**RE: Case No. 22-0752-EL-BLN  
Lee Extension 138 kV Transmission Line Project  
Notice of Adjustment**

After consulting with OPSB Staff, AEP Ohio Transmission Company, Inc. (the “Company”) provides the following notice of adjustment to the above referenced project.

FINAL LOCATION FOR STR 7

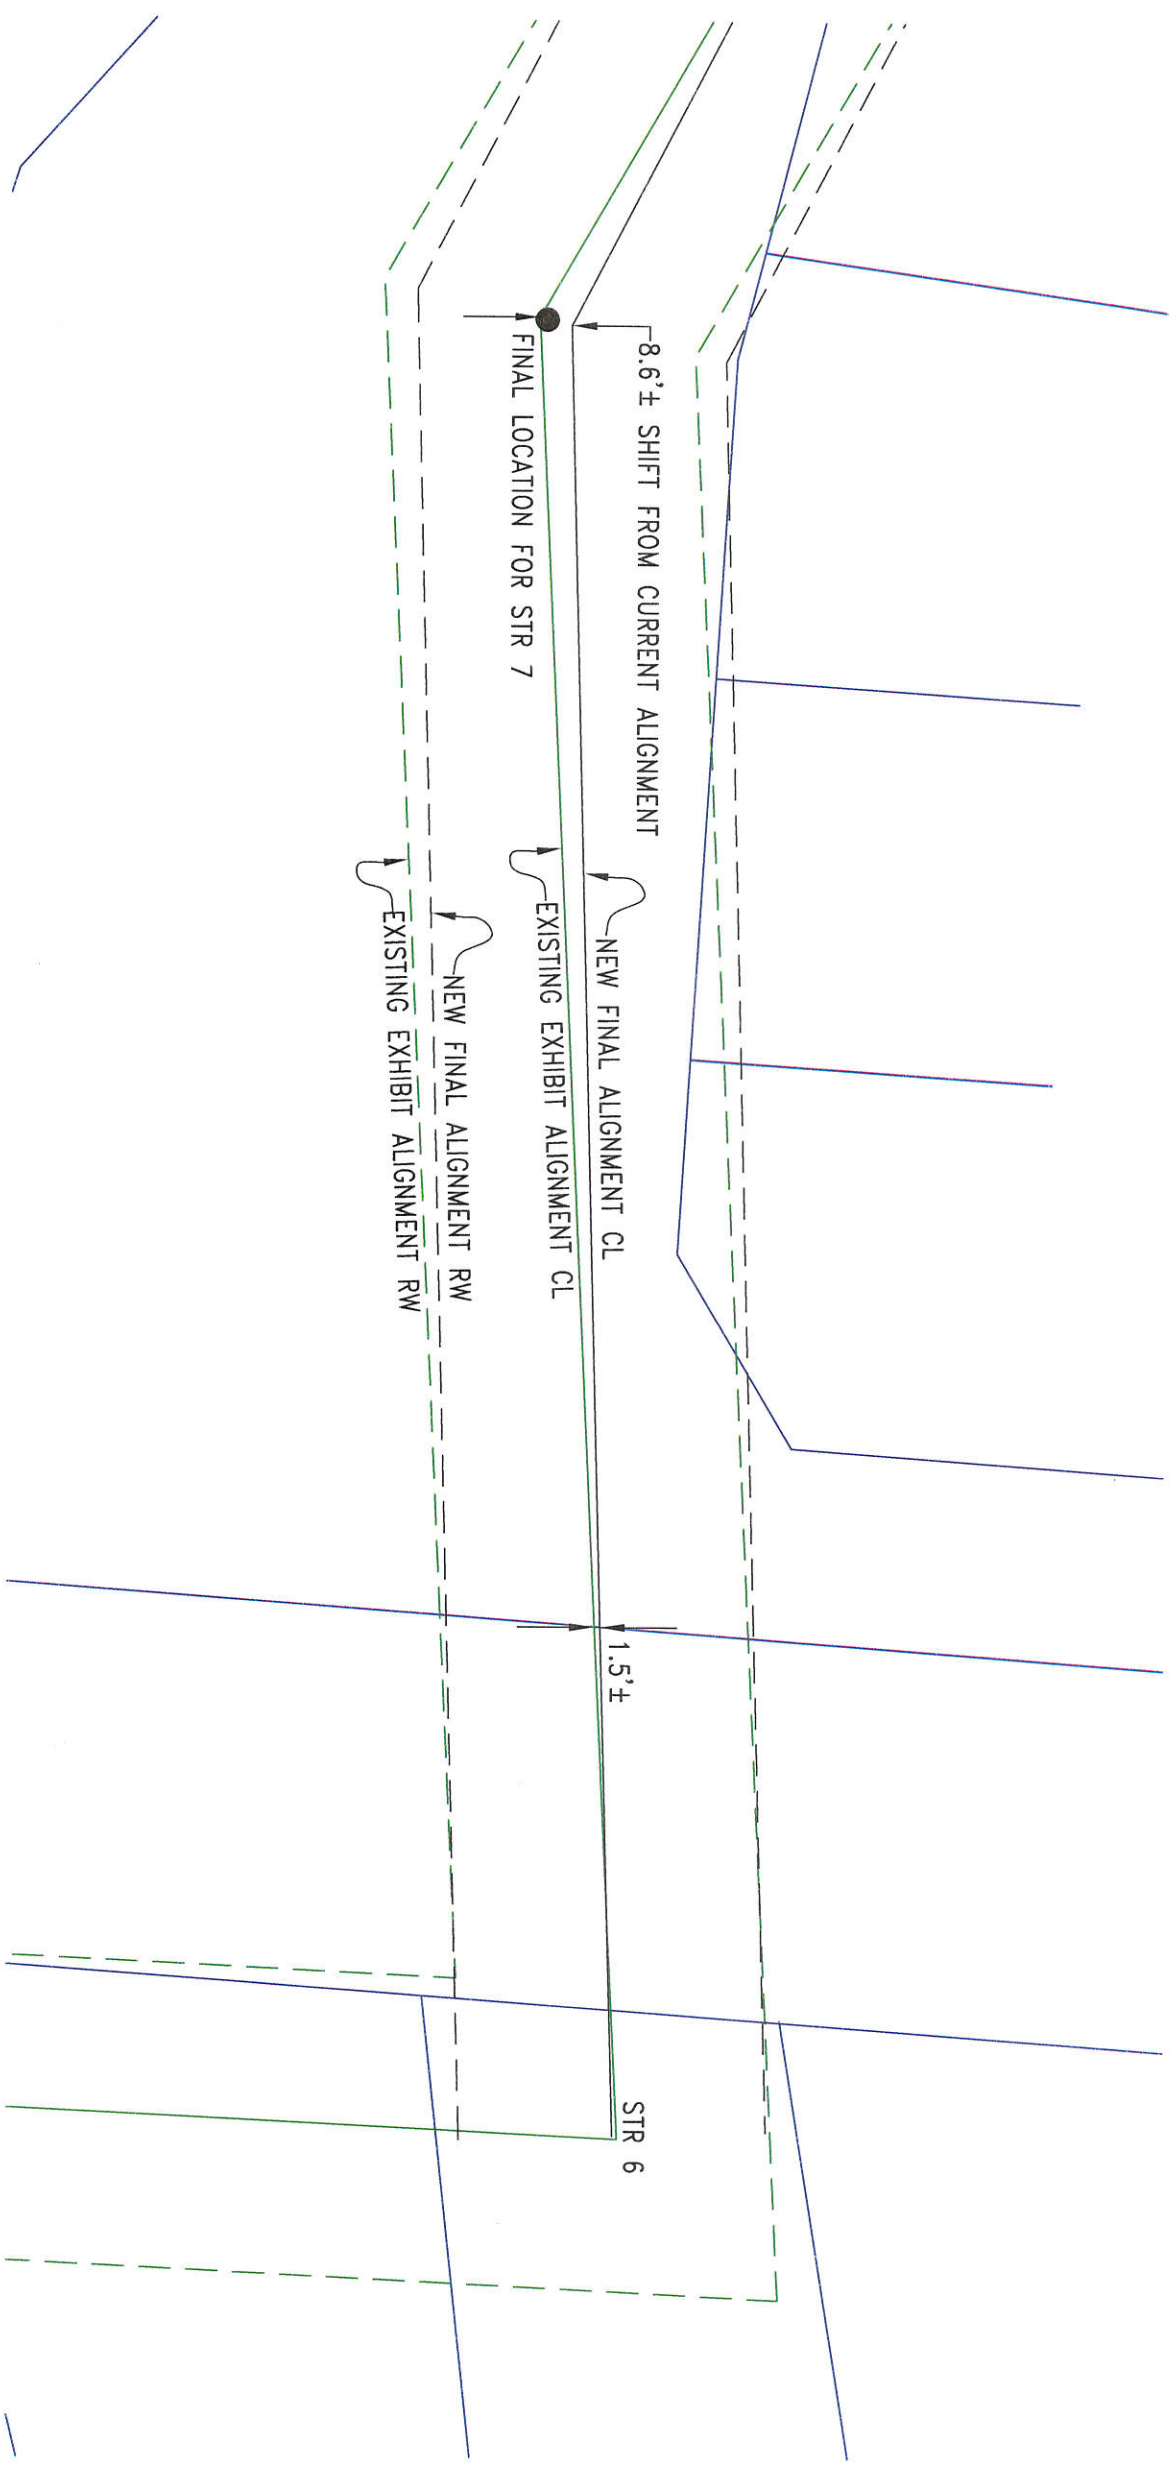
The Company determined that the transmission line route shown on Figure 2 in the Company’s filing on August 5, 2022 needs to be adjusted due to construction impacts to the Ohio Department of Transportation’s (ODOT) drainage swell. The Company determined that Structure 7 would need to be shifted 8.6’ north, within the proposed right-of-way, to avoid impacts to the ODOT drainage swell, see attached exhibit. However, the application text remains unchanged based on the proposed shift and does not affect any new property owners, impact any additional wetlands or streams, or require additional tree clearing. Attached is an exhibit (Lee 138 kV Extension – STR 7 Shift Exhibit) showing the proposed Structure 7 shift. The Company will also provide updated shape files prior to the start of construction.

8.6'± SHIFT FROM CURRENT ALIGNMENT
